GROUND FLOOR PLAN

STANDARD DESIGN OF GENERAL HOUSING.  
CAT-2, SECTOR, 51 - A. CHANDIGARH. (U.T.)

# CHANDIGARH HOUSING BOARD

STANDARD DESIGN OF GENERAL HOUSING. CAT-2, SECTOR, 51 - A. CHANDIGARH. (U.T.)  
GROUND & TERRACE FLOOR PLAN

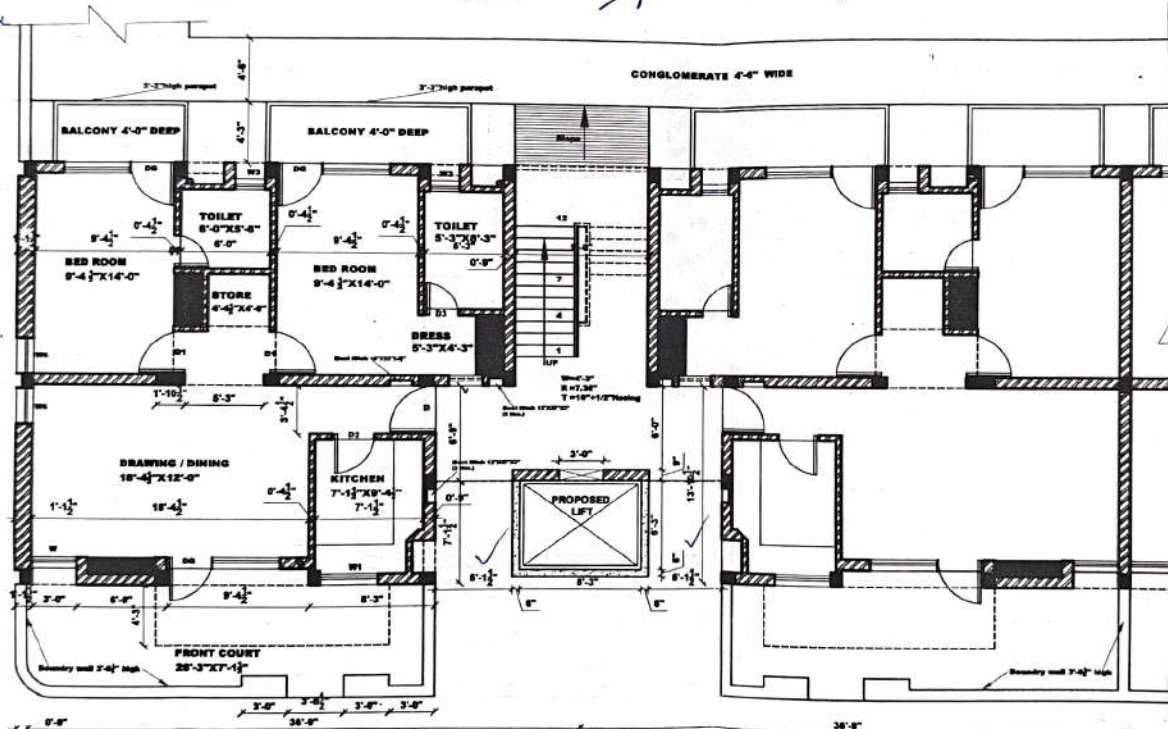
Lifts can be provided in this category as far as structural aspect is concerned subject to shifting of any services coming from the area of lifts. Further the slab at terrace level is required to be dovetailed for lift area. The rectification of slabs over of lift area is to be done under the supervision and guidance of empowered Structural Engineer of CHD Admn.

Lift Proposal is Architecturally O.K.  
However its location & any additional area may be seen by T.P member

The lift can be accommodated within the Housing Board area / layout plan subject to structural stability, electrical, architectural aspects & area available for need based requirements as no zoning is available.

PH internal services i.e. G.I. pipes and CI pipes are passing through the proposed lift well. The applicant, therefore, may have to arrange the shifting of these services at an appropriate location/place at his own cost before taking up the installation of lift at proposed location.

Lift can be provided subject to compliance the Norm as per NBC in view of fire safety and escape route not be obstructed.

It has been observed that main electricity supply cable and Telephone cables are passing through along/under the proposed lift well. The applicant may have to shift these services at his own cost before taking up the installation of lift at proposed location.
